SERVICE INFORMATION LETTER

Clarification on the Engine Isolator Inspection Criteria

LM-827-SA2, -SA7, -SA10, -SA11

LM827-71-001

FIGURE 1

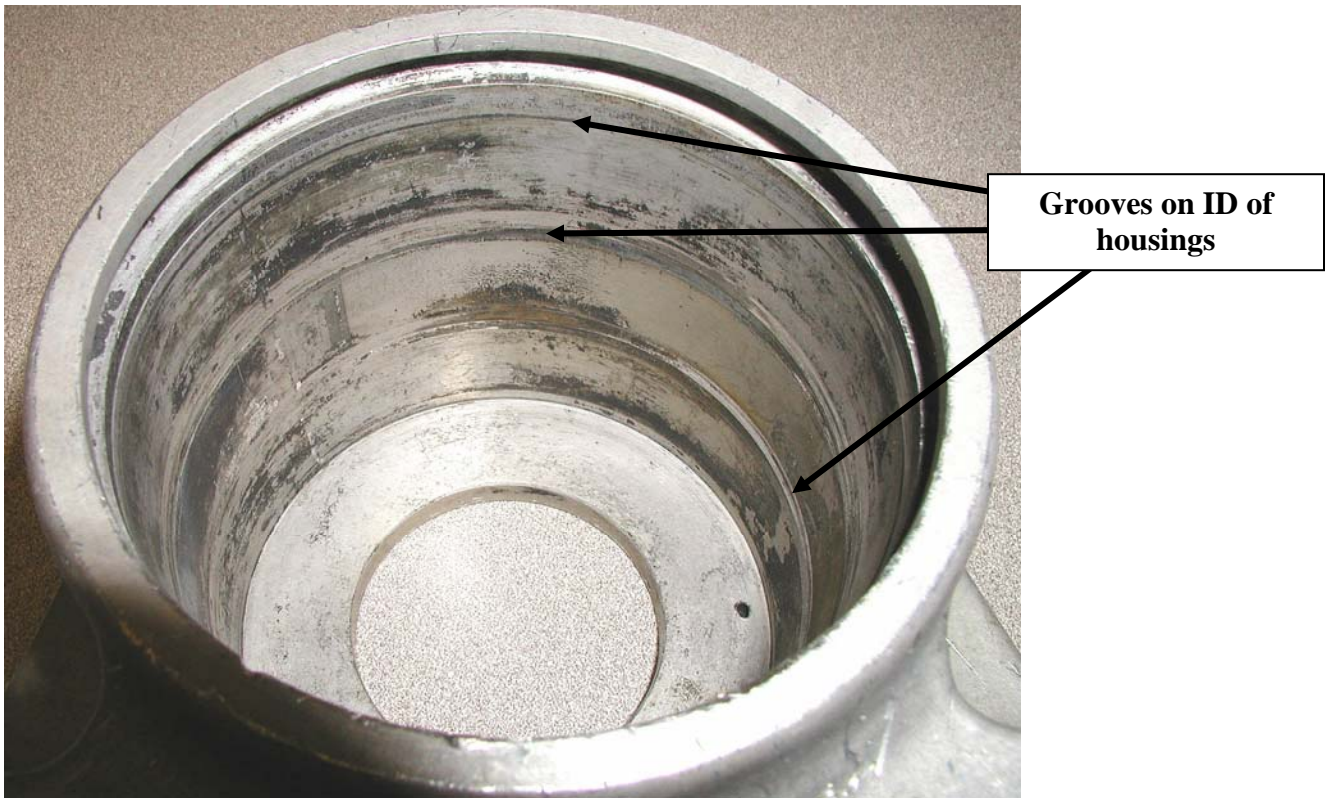
1. It has come to Lord Corporation's attention that the housings for the LM-827-SA2, -SA7, -SA10 and -SA11 have some excessive wear and damage both on the exterior of the housing and the inner diameter. The CMM is somewhat vague for these parts and this service letter will clarify the inspections.
2. With time, wear takes place between the rubber sandwiches and the inner diameter of the housing resulting in grooves in the housing as shown in Figure 1.

3. These grooves should be machined out locally (the entire ID of the housing does not have to be machined, just where the groove has formed) with 64 micro-inches maximum surface finish with a minimum transition radius of .075 inches (no sharp edges). The maximum inner diameter is as follows:

- The inner diameter for the LM-827-SA10 housing, LM-827-46, should have a maximum diameter of 3.617 inches. If this value is exceeded, the part should be replaced.

- The inner diameter for the LM-827-SA11 housing, LM-827-45, should have a maximum diameter of 3.077 inches. If this value is exceeded, the part should be replaced.

- The inner diameter for the LM-827-SA2 housing, LM-827-15, should have a maximum diameter of 3.077 inches. If this value is exceeded, the part should be replaced.

- The inner diameter for the LM-827-SA7 housing, LM-827-35, should have a maximum diameter of 3.077 inches. If this value is exceeded, the part should be replaced.

- If there remains some local wear or damage to the inner diameter after machining, it is acceptable to polish this area (to a 64 micro-inches maximum surface finish with .075 inch minimum radius) if the area is less than an inch long and does not exceed .030 inches deep from the original surface prior to machining the inner diameter. If this is exceeded, replace the part.

Figure 4

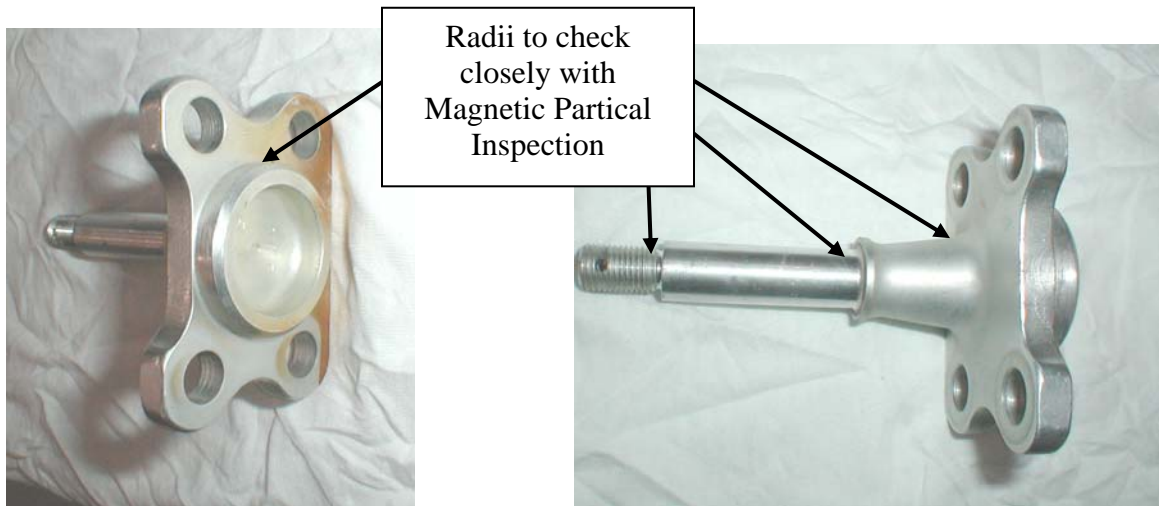
6. If there is any machining or polishing or wear that exposes the bare material on the housings, anodized per MIL-A-8625, Type I, Class 1, Dichromate Seal.
7. These housing must be penetrant inspected per the CMM.
8. The stem brackets LM-827-2 and LM-827-39 should be non-destructive tested (NDT) per the CMM for cracks with special review of the radii as shown in Figure 4. If any cracks are found, replace the part. No nicks or gouges are allowed in these radii.

Other areas of the part can have nicks or gouges to a maximum depth of .02 inches from the original surface and no longer than .25 inches. These areas must be blended out with 64 micro-inches maximum surface finish with .075 inch minimum radius. Blended areas must be Cadmium plated per QQ-P-416, Class 3, Type II

Figure 5

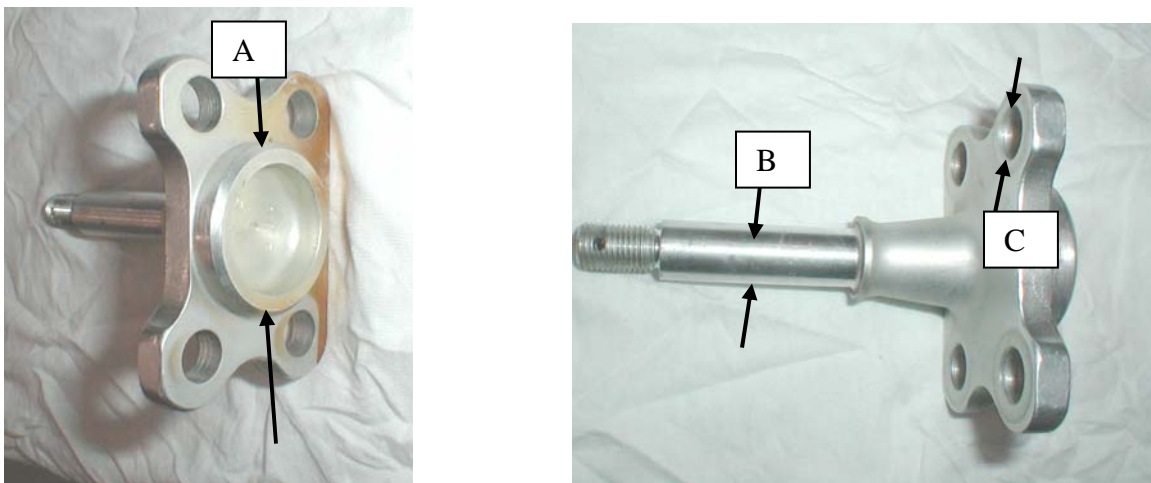
9. The LM-827-2 and LM-827-39 brackets should be checked for wear in the areas shown in Figure 5 per the requirements of Table 1. If they don't meet these requirements, replace the parts.

Part Number	A Dimension Min (in.)	B Dimension Min (in.)	C Dimension Max (in.)
LM-827-2	1.493	.555	.464
LM-827-39	1.493	.644	.464
